PLANNING COMMITTEE

19th August 2015

ADDITIONAL PAGES

Additional Representations on Schedule Items

Northern and Southern Routes Drawing

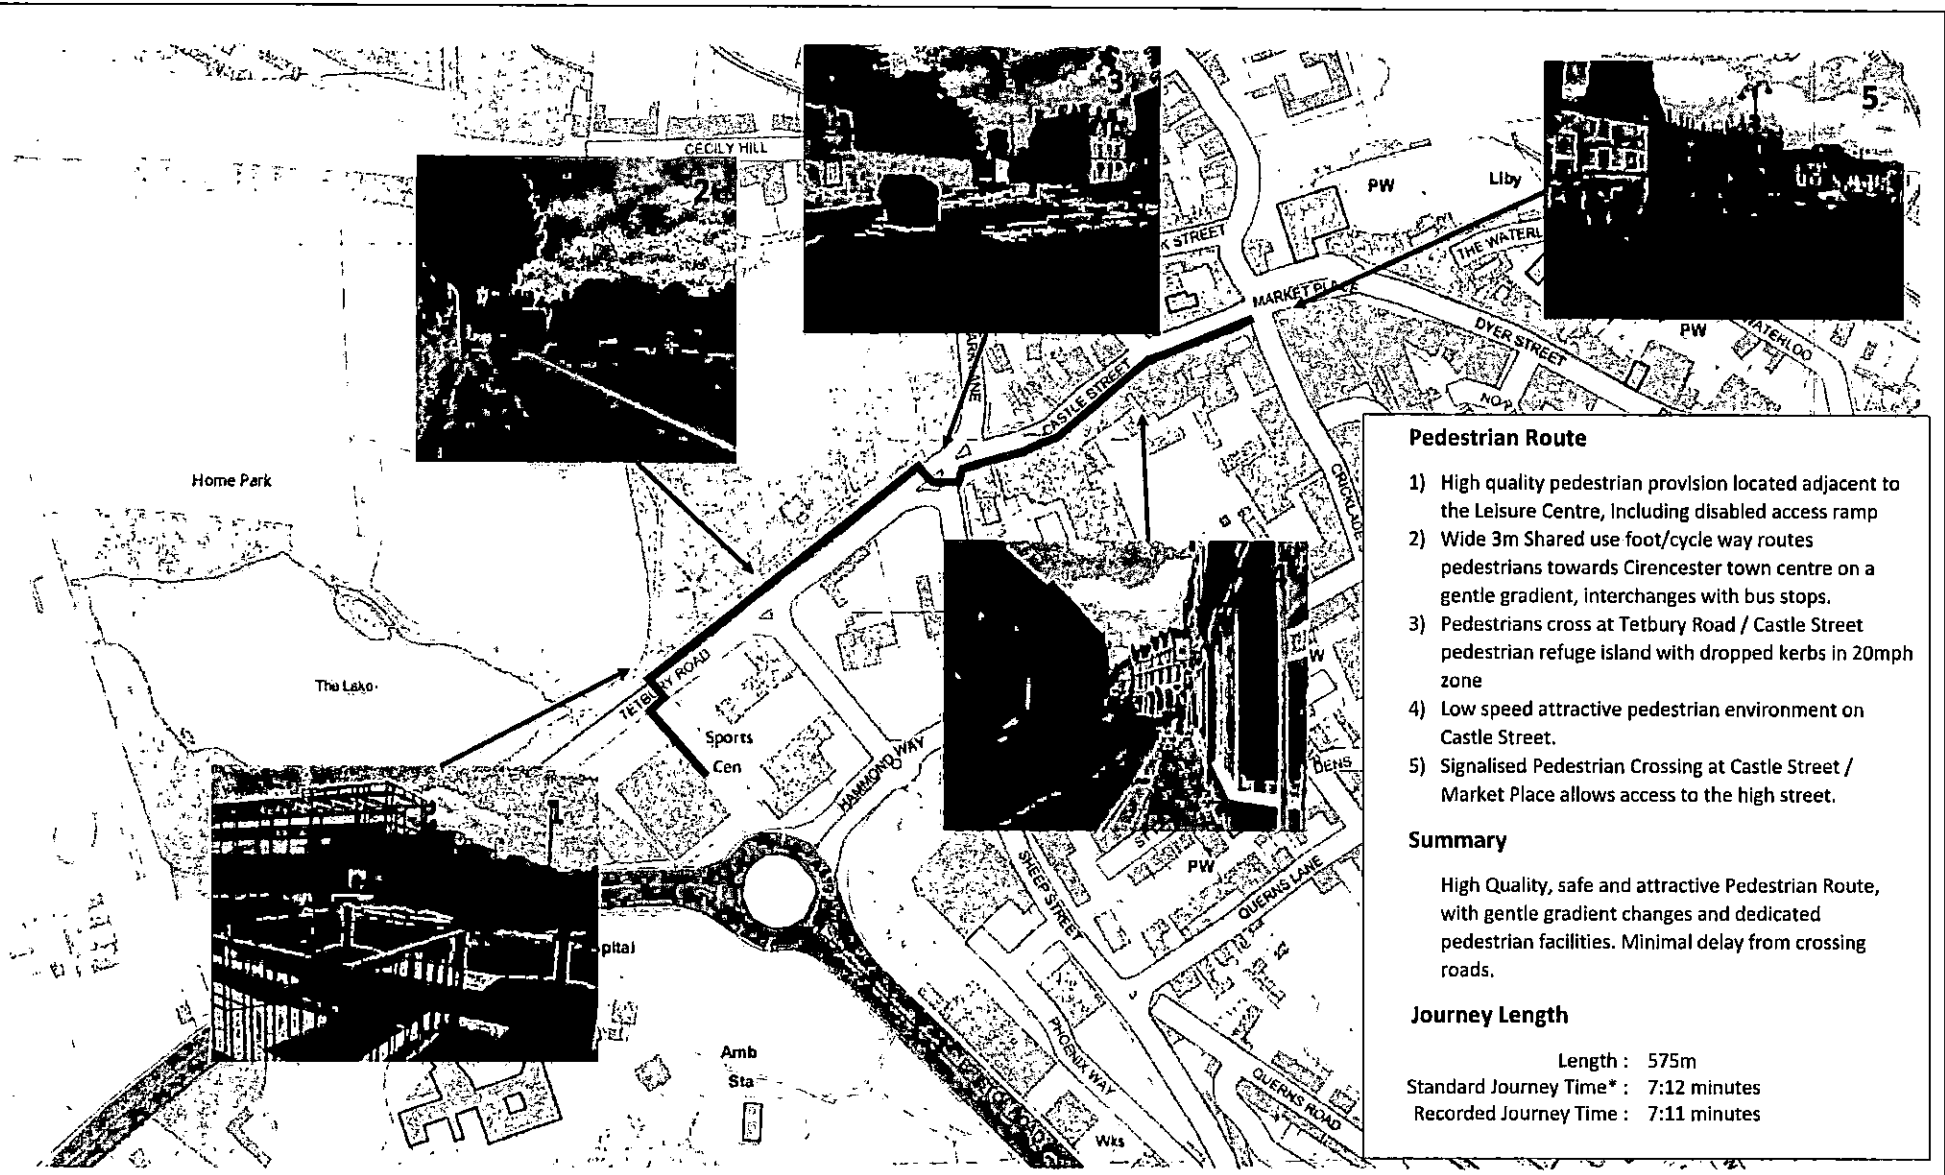
The **Northern and Southern Routes** illustrate the routes from the leisure centre to the junction of Market place/Castle Street/Cricklade Street. The plans detail the distances, times as well as commentary on the pedestrian environment. The information illustrates that the leisure centre is well linked to the town centre and any "potential" link via the application/CIR.3 site is of questionable value.

Through Site Route Options Drawing

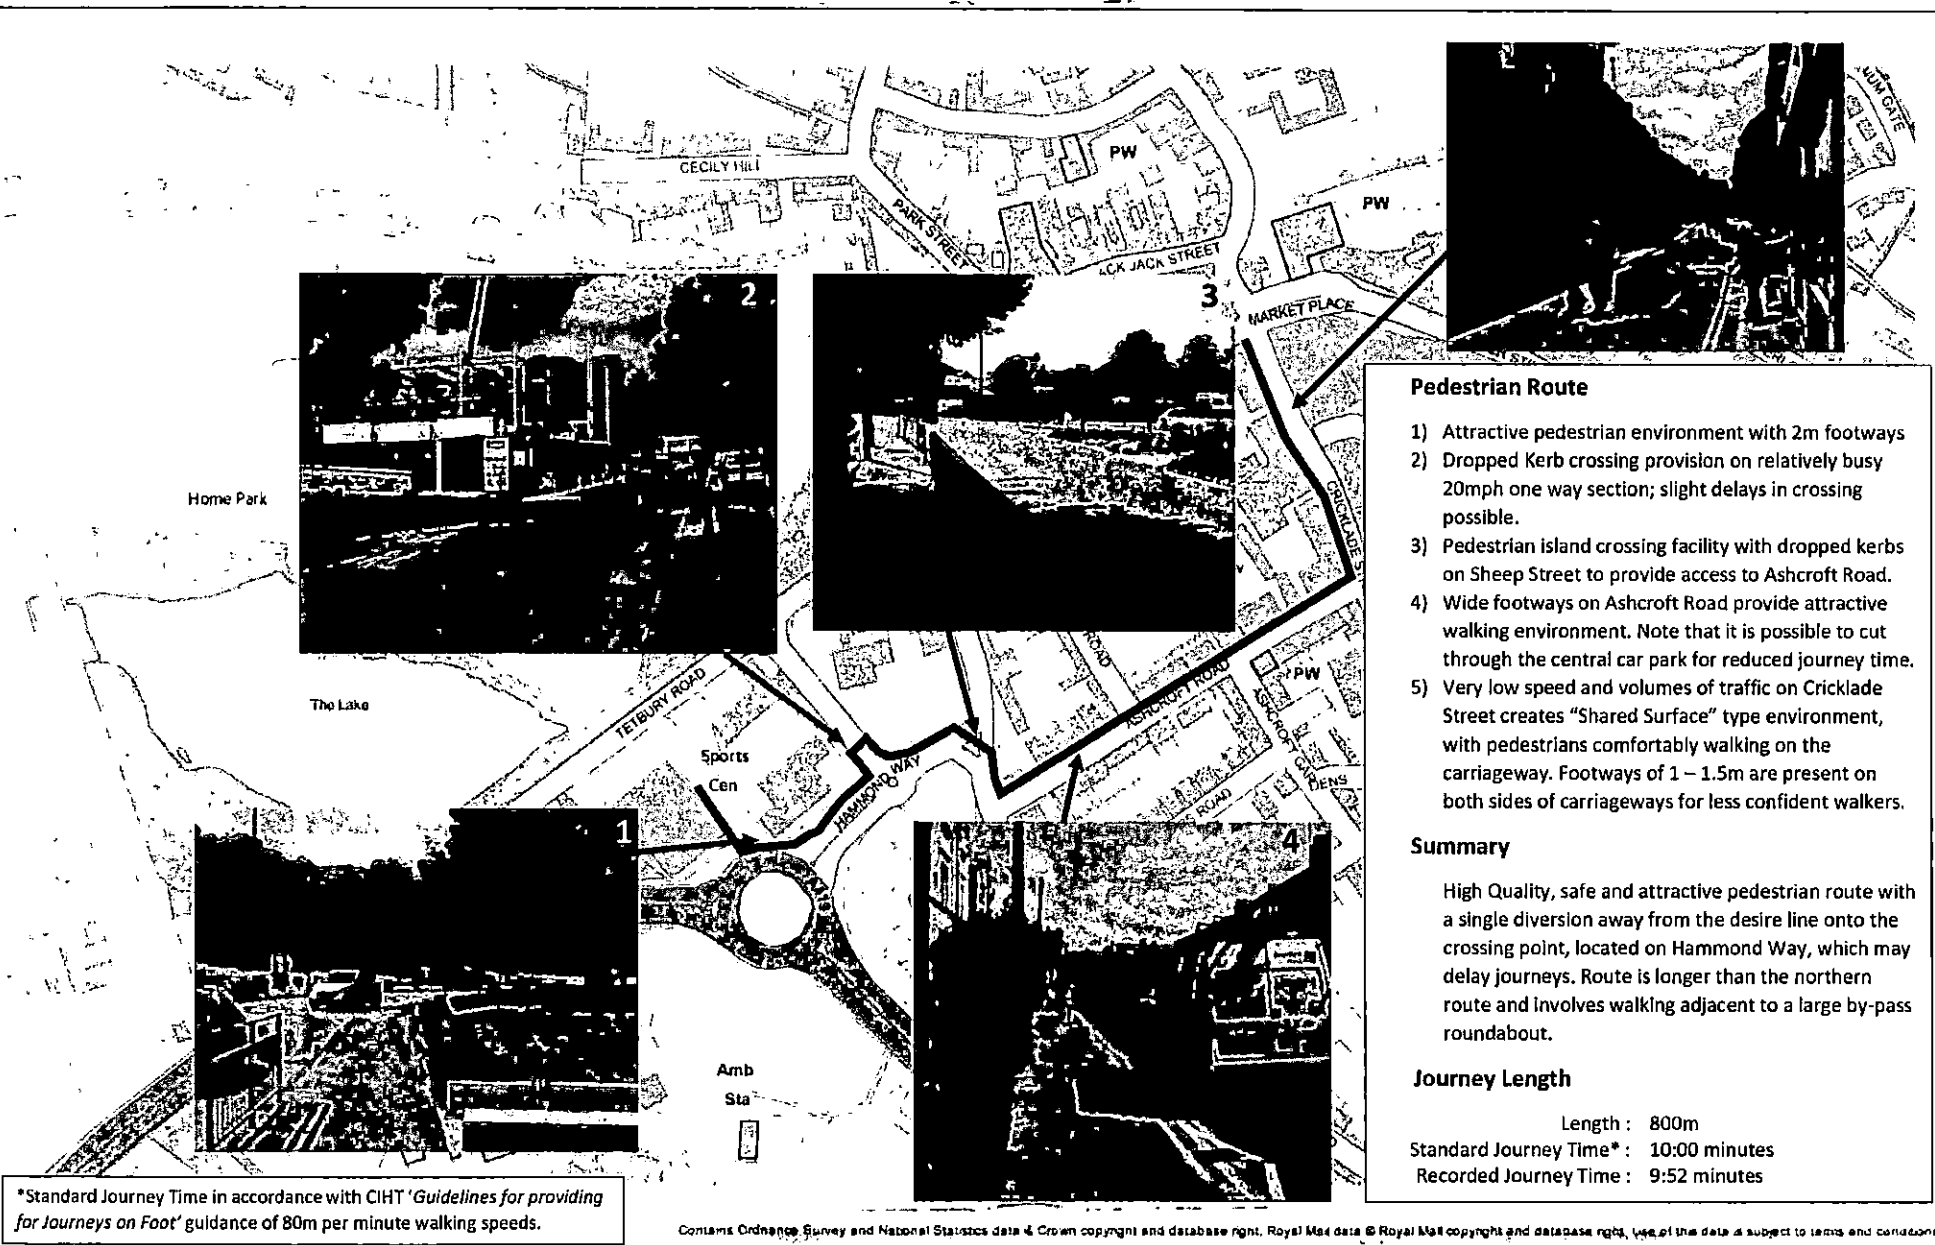
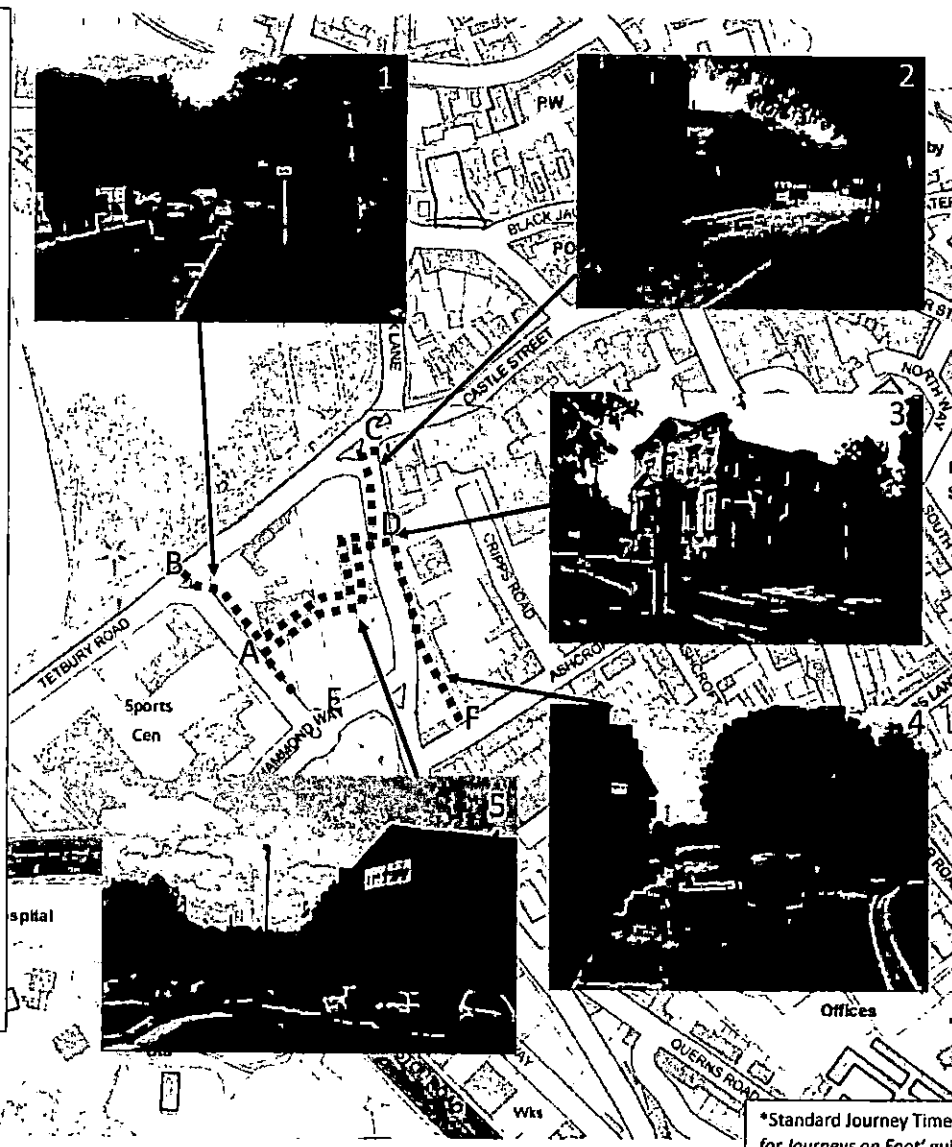
In fact, the plan of the **Through Site Route Options** demonstrates that for a prospective resident it would be a shorter and quicker journey to access the town centre using existing public routes than utilising a notional new route through the site.

I have previously touched upon the practical and heritage issues of attempting to provide a link through the site. In part this is referred to at point 5 on the drawing **Through Site Route Options**. In addition, I attach photographs of the listed wall and the comments of David Beardmore. The photographs are also helpful in that they also show the existing buildings and the negative impact that it has on the Conservation Area and the setting of the nearby Listed Buildings.

Route to Supermarket Drawing

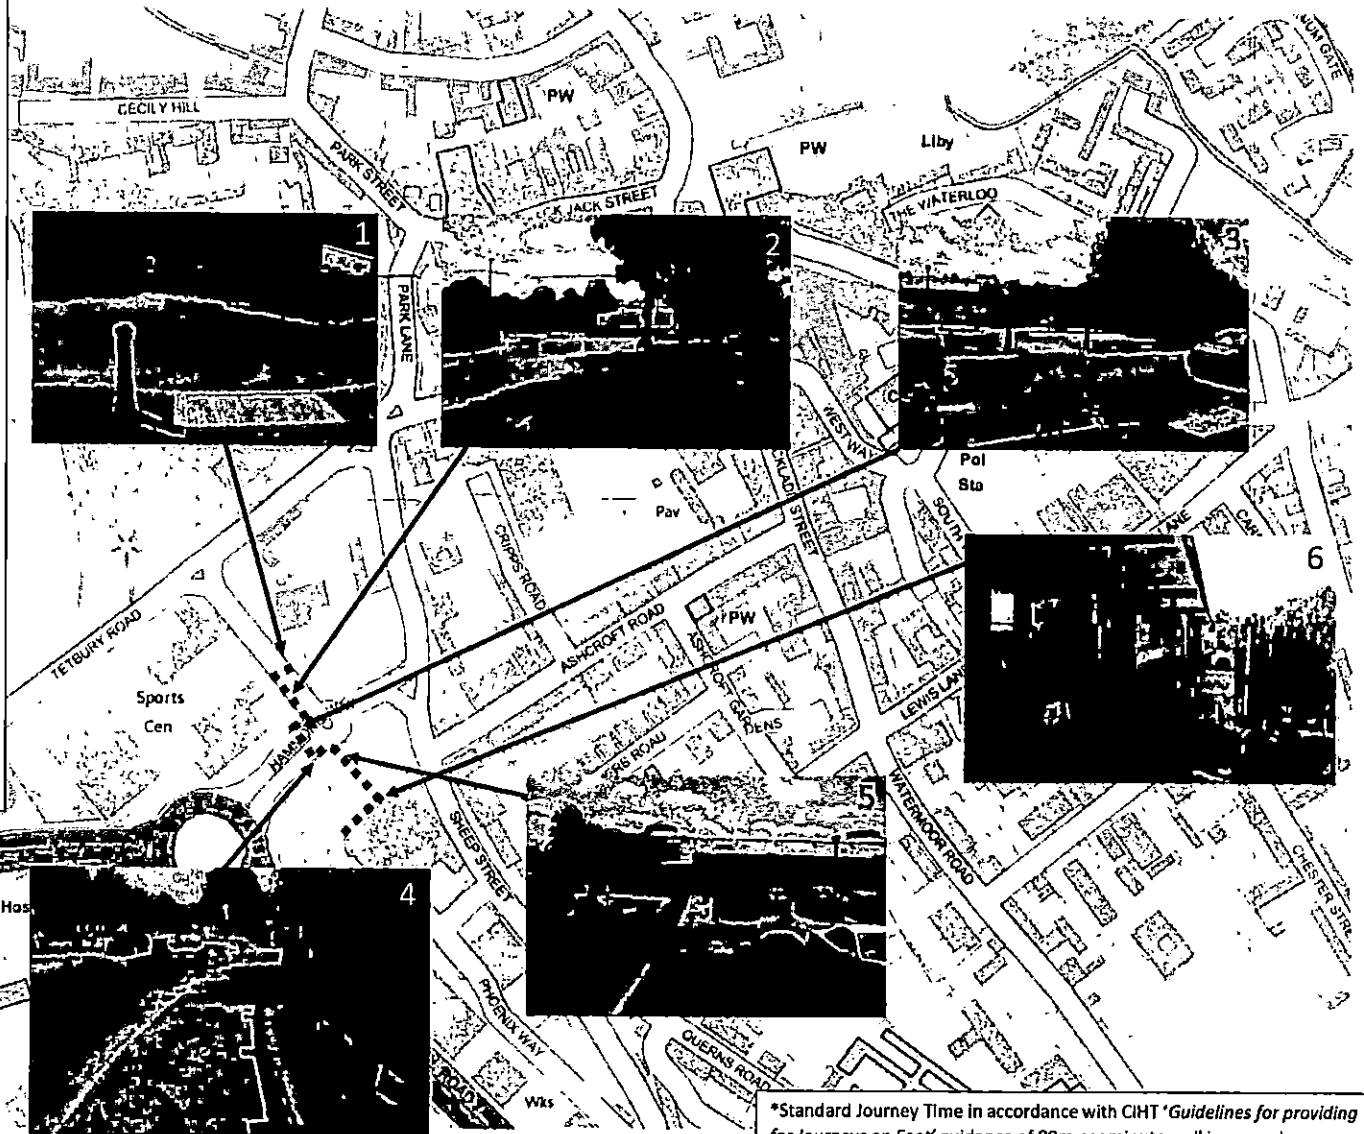
A fourth drawing entitled **Route to Supermarket** is also provided, this details how residents would access the nearby supermarket (some of this information is also within the Addendum to the Transport Statement). As is clearly illustrated the distance from the site to the supermarket is well under 5 minutes and has safe pedestrian crossings.

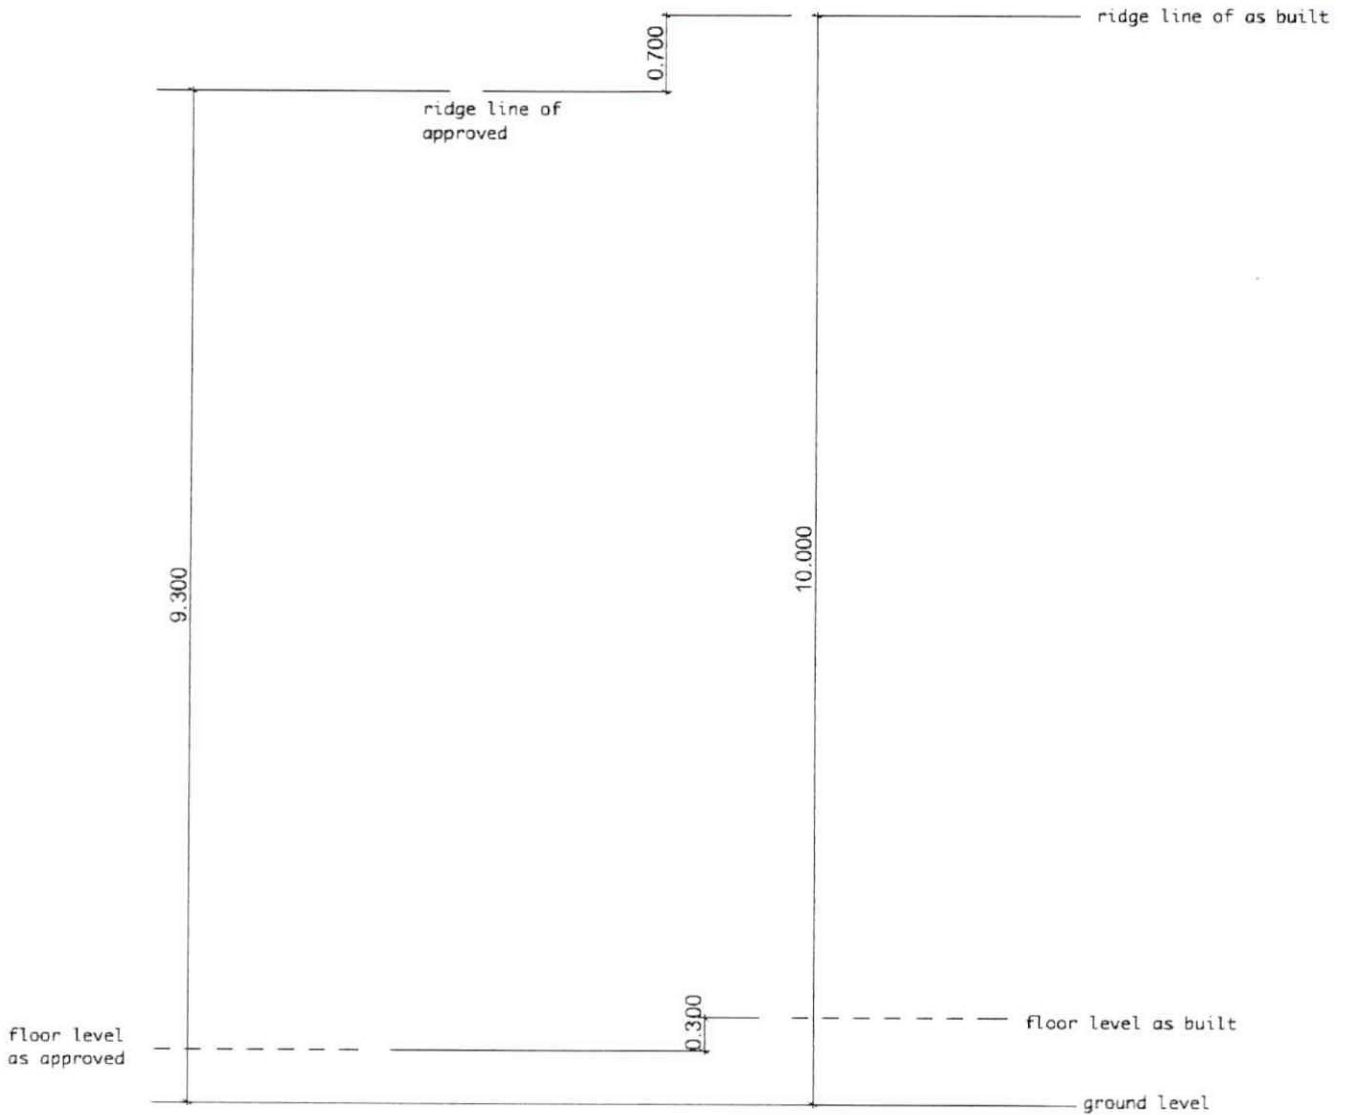
I think that you have misunderstood our point regarding your calculations and the difference in height of the building that you have arrived at and I therefore have attempted to produce a simple visual representation of your section of the planning committee statement to explain that you have unfairly counted the difference in height measured from the ground level to the ridge and then added the difference in floor levels, which subsequently falsely makes your calculated height difference higher to the detriment of our case.

In effect you have taken the ridge height difference of 700mm when measured off plan from ground levels and then said that the finished floor levels are different by 300mm and just added that to the 700mm to achieve a difference of 1000mm, the attached sketch gives a visual representation that shows the difference in floor levels is irrelevant and has no effect on the overall difference in height.

SPITFIRE BESPOKE HOMES, SITE PLAN - BOUNDARY TREATMENT, SCALE 1/500 @A2, DRAWING 1596-21B

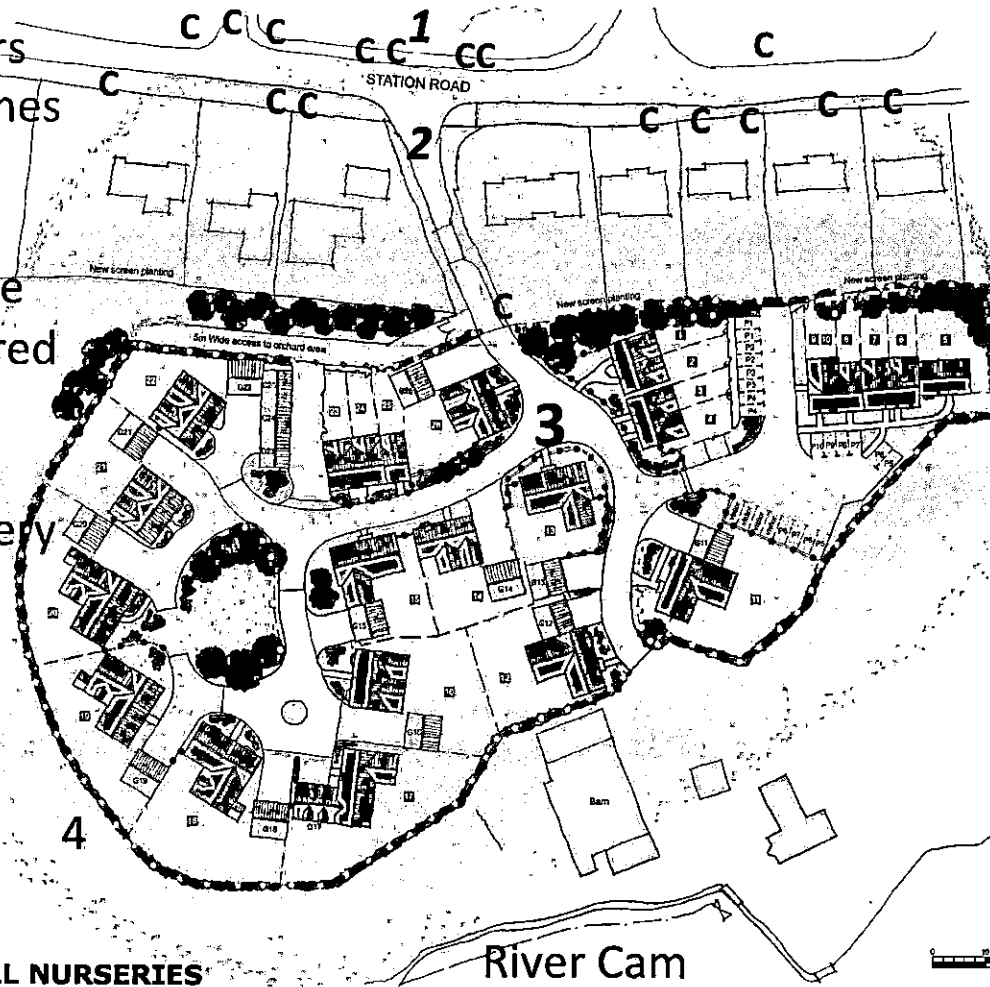
As the development includes 26 dwellings, the majority with multiple bedrooms I am surprised that no provision has been made for safe areas for children. Drawing P1067/102 shows very clearly that the road width is probably not big enough to provide safe shared facilities for pedestrians and vehicles. The car shown on the drawing is probably not representative of current vehicles as it is only 1.769m wide; a MINI for example is 1.925m! **A standard 2015 Ford Transit Van is 2.5m wide and the road widths are 5m wide without pedestrian areas so 2 delivery vehicles would not be able to pass within roadway!**

No provision has been made to access Berrington Farmhouse (*T shaped building by Banners Gate box on drawing*) P1067/102. The original access from Station Road to the farmhouse for all vehicles was a straight line. As the occupiers of the farmhouse have horses grazing on the surrounding fields I suggest that a curved access road around plot 13 and between plots 11 & 12 is totally impracticable for farm vehicles including horse transporters and trailers.
